**Reference: CHEO Integrated Treatment Centre, 401 Smyth Road**  
**Response to March 19<sup>th</sup> and February 18<sup>th</sup> Traffic Comments**  
**Novatech File No. 122210**

Please see the following responses to the municipality's traffic related 1<sup>st</sup> Review comments dated March 19, 2025 and February 18, 2025, regarding the Site Plan application for the new 'Integrated Treatment Centre' building within the campus of the Children's Hospital of Eastern Ontario (CHEO).

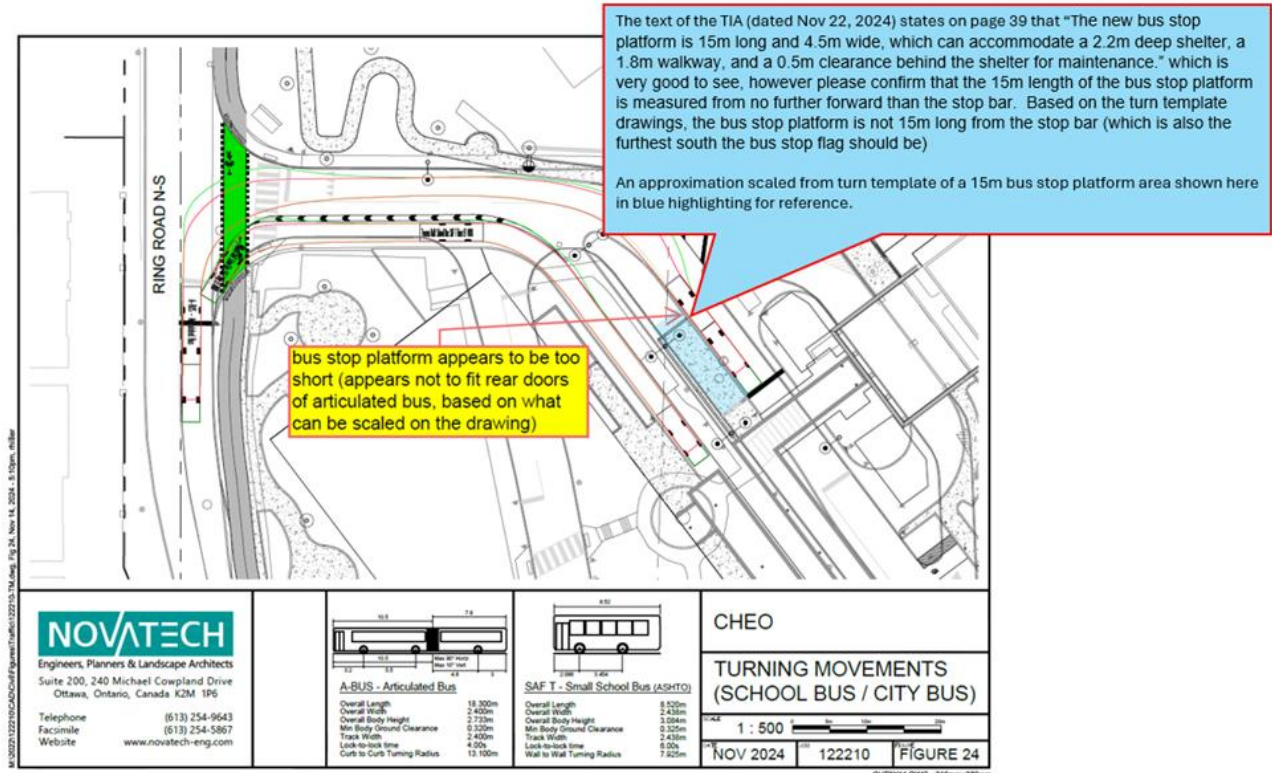
*Consider providing Rb-19 Do Not Enter and Rb-21 One Way signage at the egress of the CHEO Non-Emergency Access where it intersects with Ring Road (E-W).*

**Response:** These are shown in the updated drawings.

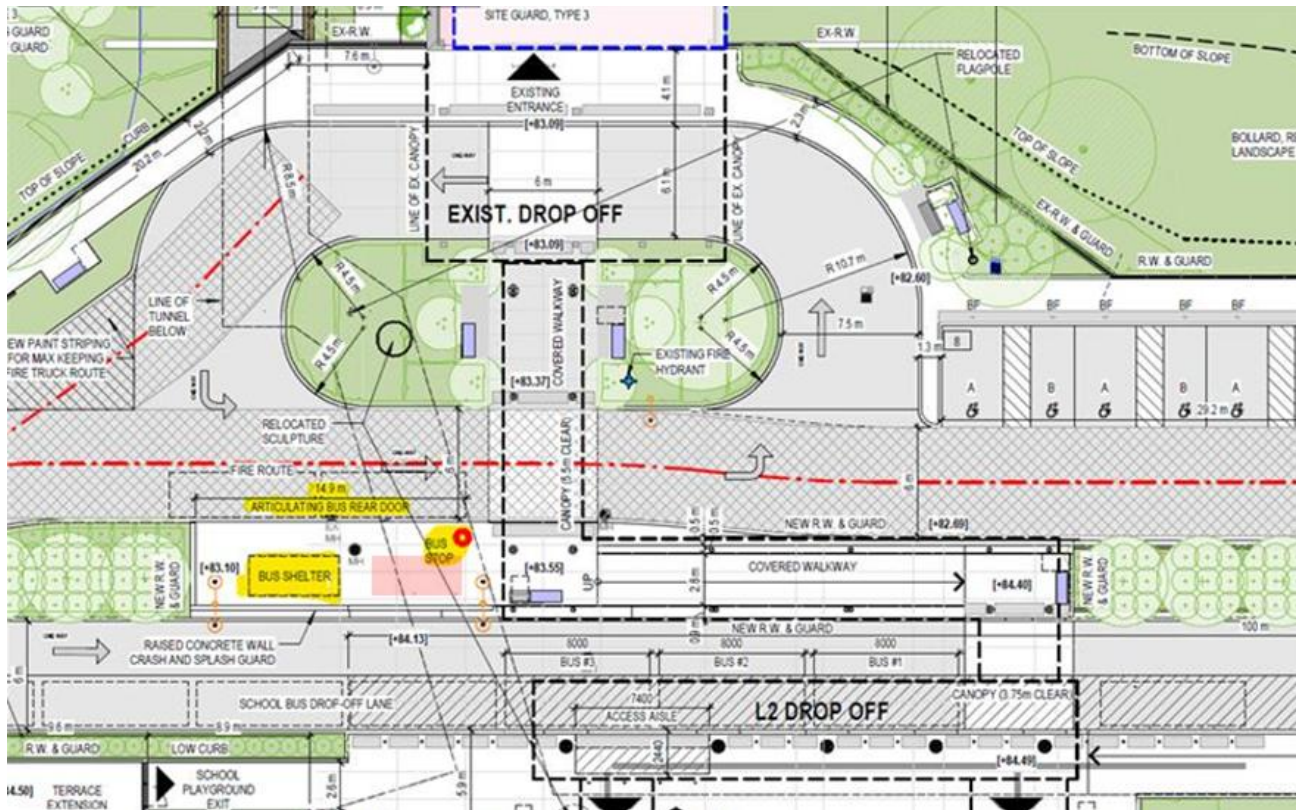
*With the change to the CHEO Non-Emergency Access to be one-way, consider relocating the northbound stop bar / stop sign on Ring Road (N-S) northwards to the 'Rotel' access to normalize the all-way stop control. Relocate the northbound Wb-1 Stop Ahead sign to match. Also recommend removing the redundant PXO pavement marking and signage at this all way stop control. Finally, remove the proposed Rb-84a and Rb85t signage. Refer to markup below:*

Please confirm that the 15m length of the bus stop platform is measured from no further forward / south than the stop bar.

**Response:** The 15m bus stop platform has been provided, and the stop bar has been relocated so that the bus stop platform begins at the stop bar. This is shown in the revised Pavement Markings and Signage Drawings.

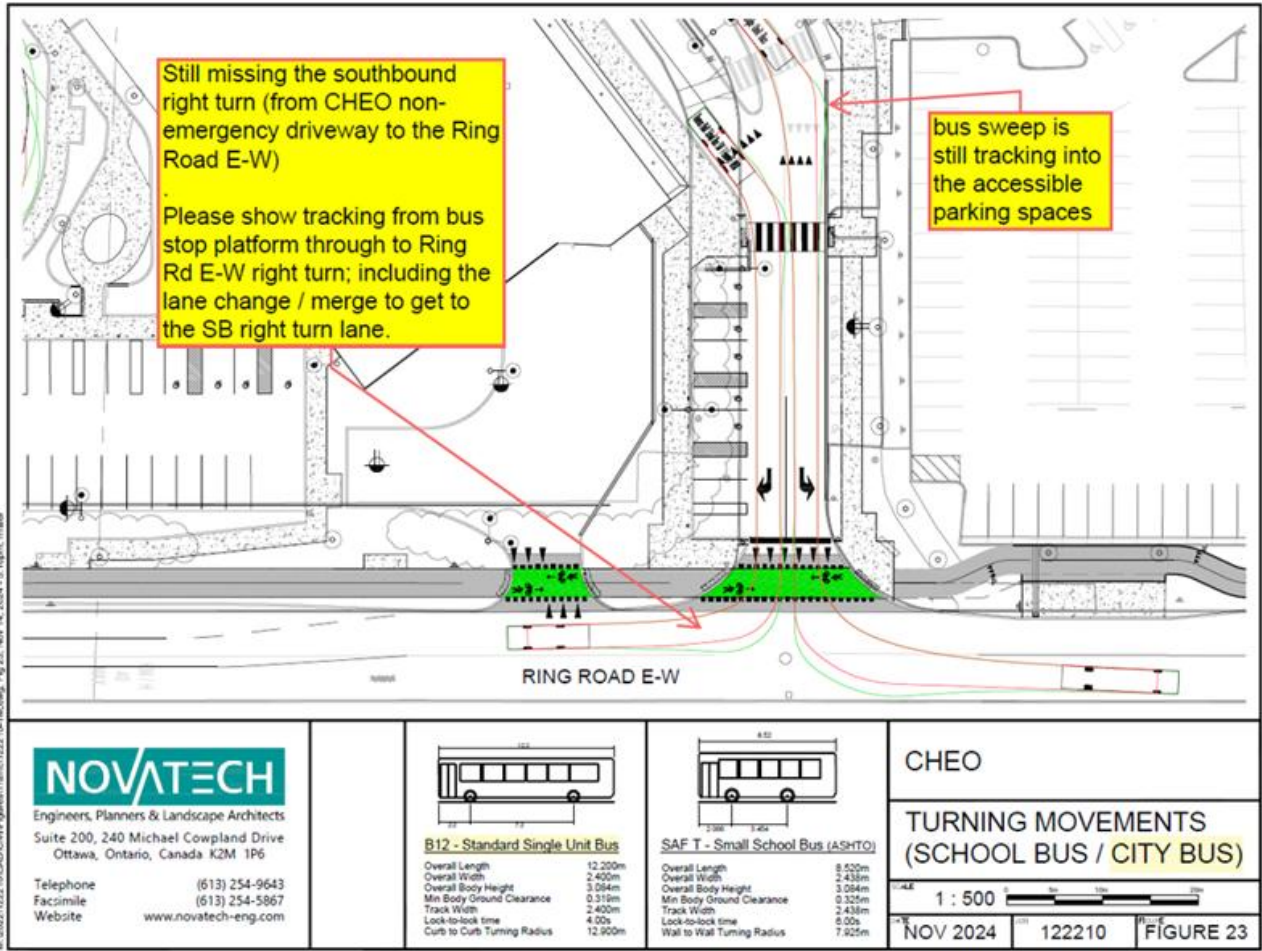
The bus stop shelter is shown in the TIA Site Plan is shown positioned further away from the bus stop flag (at the stop bar) than would be typical. Can the shelter be positioned closer to the bus stop sign in order to minimize walking distance for customers waiting for the bus? Although there is a planned maintenance hole (MH) within the bus stop platform area, it would appear that the bus stop shelter footprint on the site plan could be adjusted to the south (closer to the crosswalk) without impacting the MH. Mock-up in red highlighting below.

**Response:** The bus shelter has been relocated and placed as close as possible to the bus stop flag.

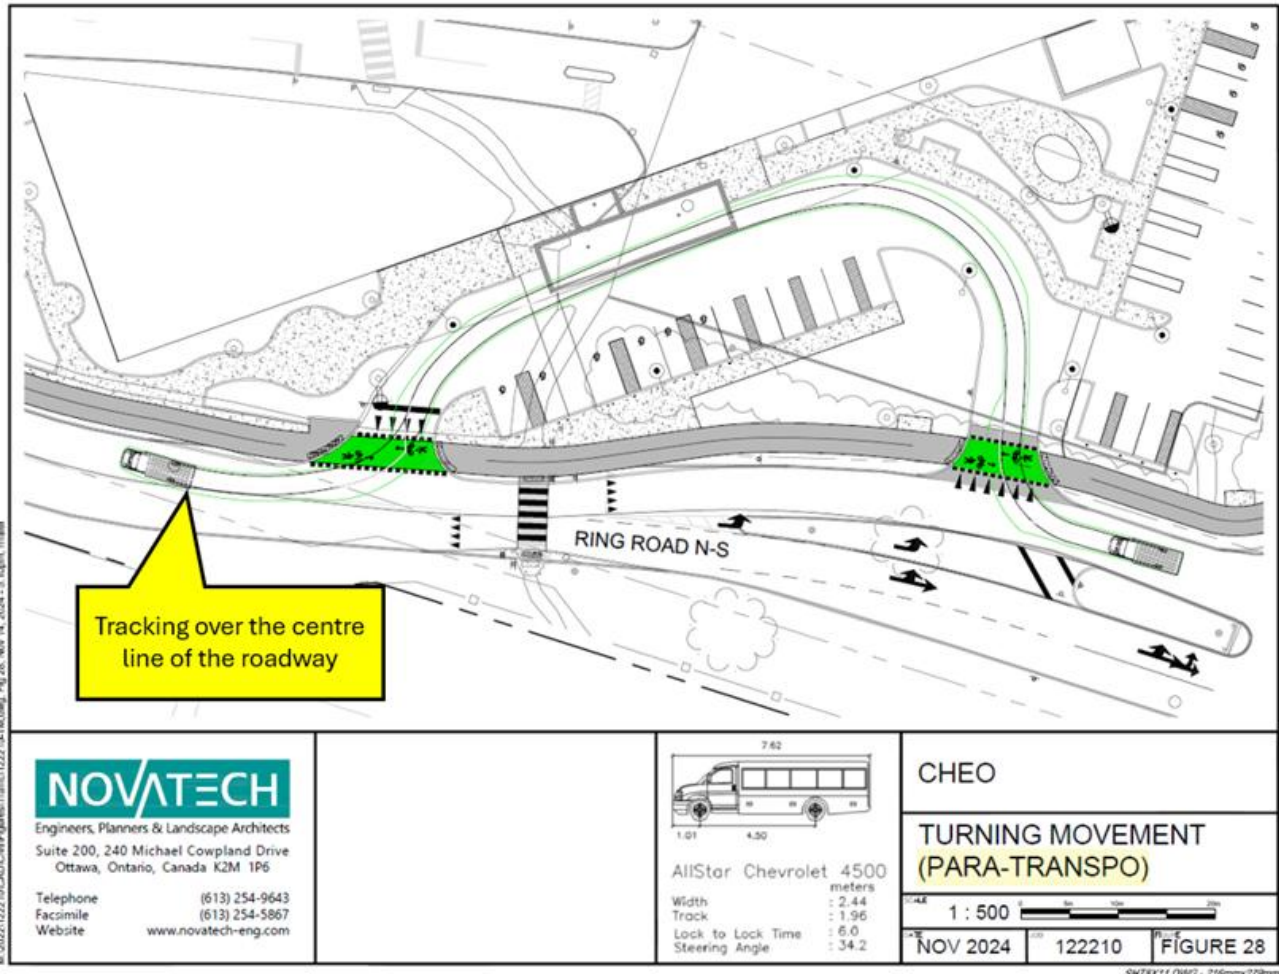
*Also noted with the turning templates, there are still a few places where the bus is tracking outside of its lane:*

- *The conventional buses are tracking over the accessible parking spaces along the CHEO driveway*

- The Para Transpo bus is shown tracking over the centre line of the Ring Road (N-S)

**Response:** Updated turning movements have been provided in the updated TIA report.

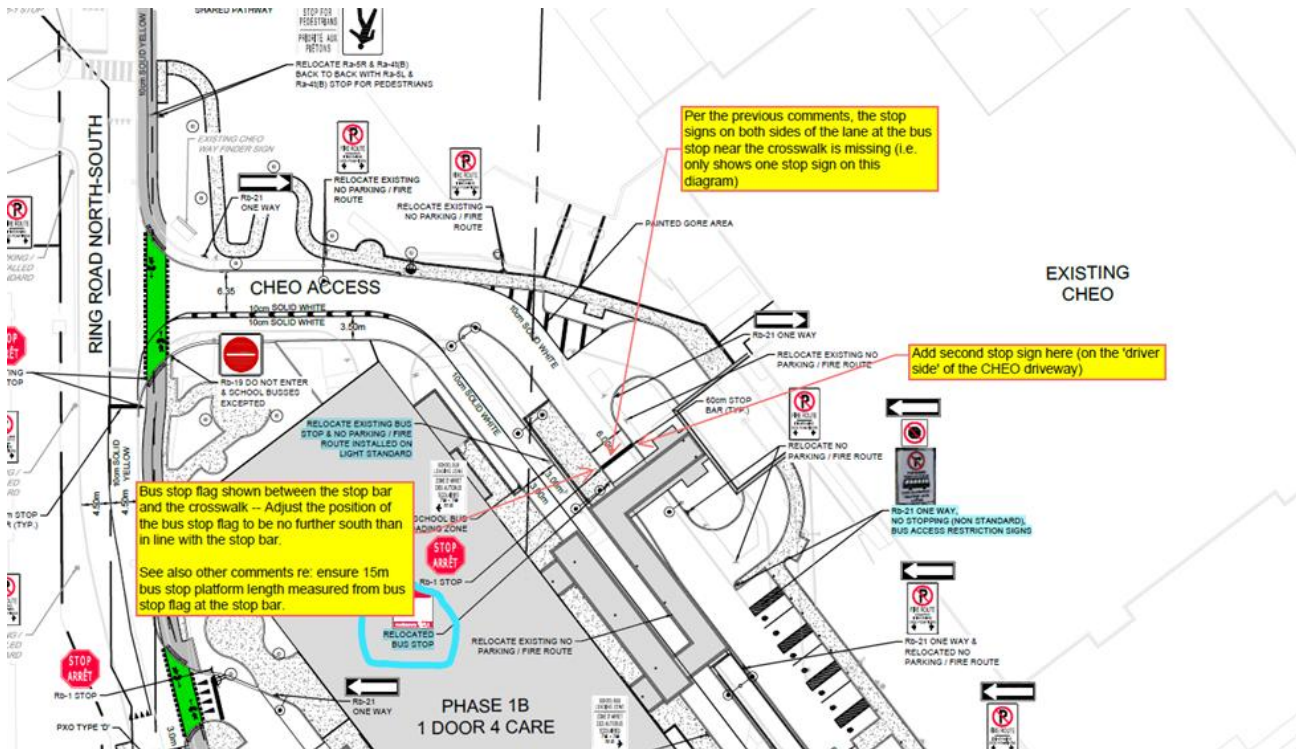
*In the Proposed Pavement and Markings drawing the requested second stop sign is missing. Add the requested second stop sign to have stop signs on both sides of the CHEO driveway roadway at the stop bar before the cross walk (one on driver side, one on passenger side). The goal for the dual stop signs is to ensure that no vehicles try to pass any vehicle, but in particular a stopped transit bus, near the crosswalk.*

**Response:** Stop signs have been provided on both sides of the CHEO driveway roadway at the stop bar in the revised Pavement Marking and Signage drawings.

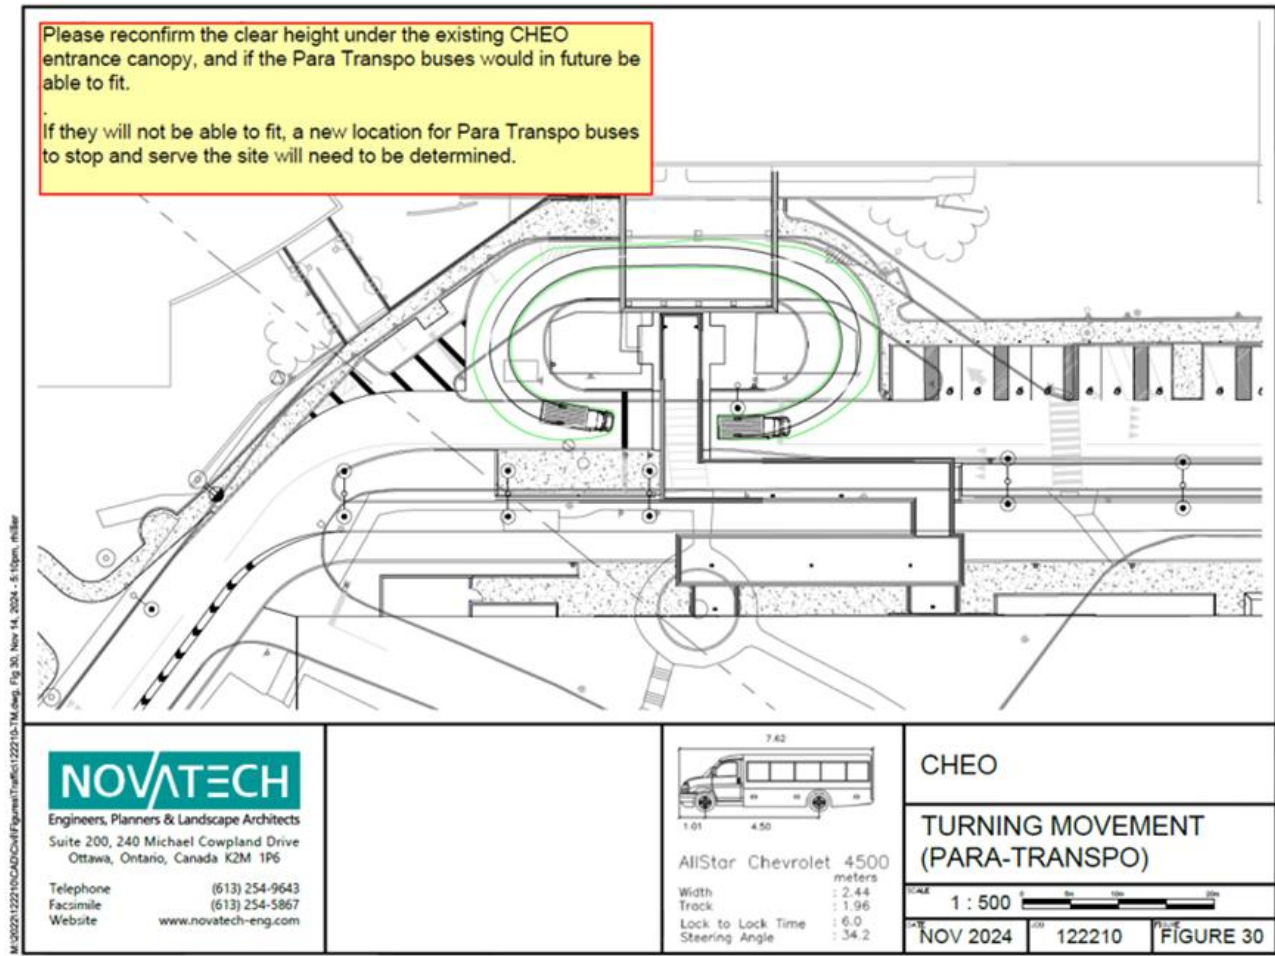
- As a part of conversations with the constructor during the current tunnel construction works, it was confirmed that the existing CHEO canopy is not tall enough to accommodate the Para Transpo buses. Subsequent to this we were also able to get internal clarification that there is one named stop for Para at CHEO, but functionally it is two stops – with the Para buses (prior to construction detour) staying on the driveway northbound and stopping near / at the stop sign before the conventional bus stop, and for the contracted taxis and vans for Para Transpo being shorter in height were able to use the area under the existing CHEO canopy.

- Please reconfirm the clear height under the existing CHEO entrance canopy, and if the Para Transpo buses would in future be able to fit. If they will not be able to fit, a new location for Para Transpo buses to stop and serve the site will need to be determined.

*With current information we likely need to determine a secondary Para Transpo stop location for use of our Para Transpo Buses (contracted taxi sedans and vans may still be able to use the existing CHEO canopy depending on the logistics of the stop for the Para Transpo buses). This secondary Para Transpo stop may impact overall operations for transit and for the hospital traffic flow, so we would like to discuss this soon.*

**Response:** As the canopy will not be altered as part of this development it is agreed that the Para Transpo stop needs to be relocated. The Para Transpo stop will be re-located. As shown in the updated drawings the Para Transpo stop will be relocated to the accessibility parking spots east of the drop-off loop.
